High Oil Pressure Swing Clamp MF*/MD* Series

Profile Dimensions Correction Notification

Before	After
 <p>MF* MD*</p>	 <p>MF* MD*</p>

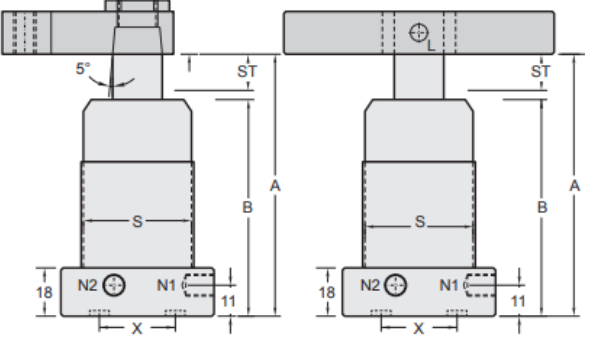
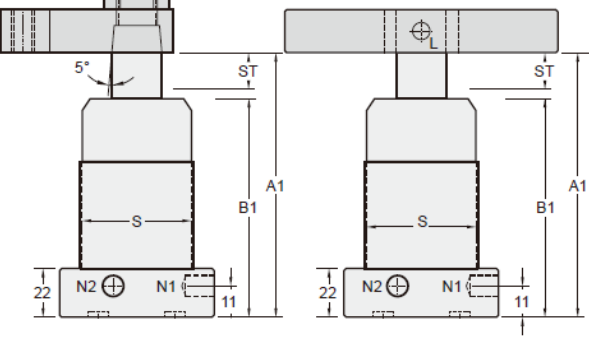
The profile dimensions of MF*/MD* series will have following dimension correction.

The catalogue dimension does not fit the product dimension.

Dimension/Size	25A	32A	40A	25B	32B	40B
Before	A	127	127	127	134	133	134
	B	102	97	98	102	97	98
	Flange Thickness	18	18	18	18	18	18
After	A1	131	131	131	138	137	138
	B1	106	101	102	106	101	102
	Flange Thickness	22	22	22	22	22	22
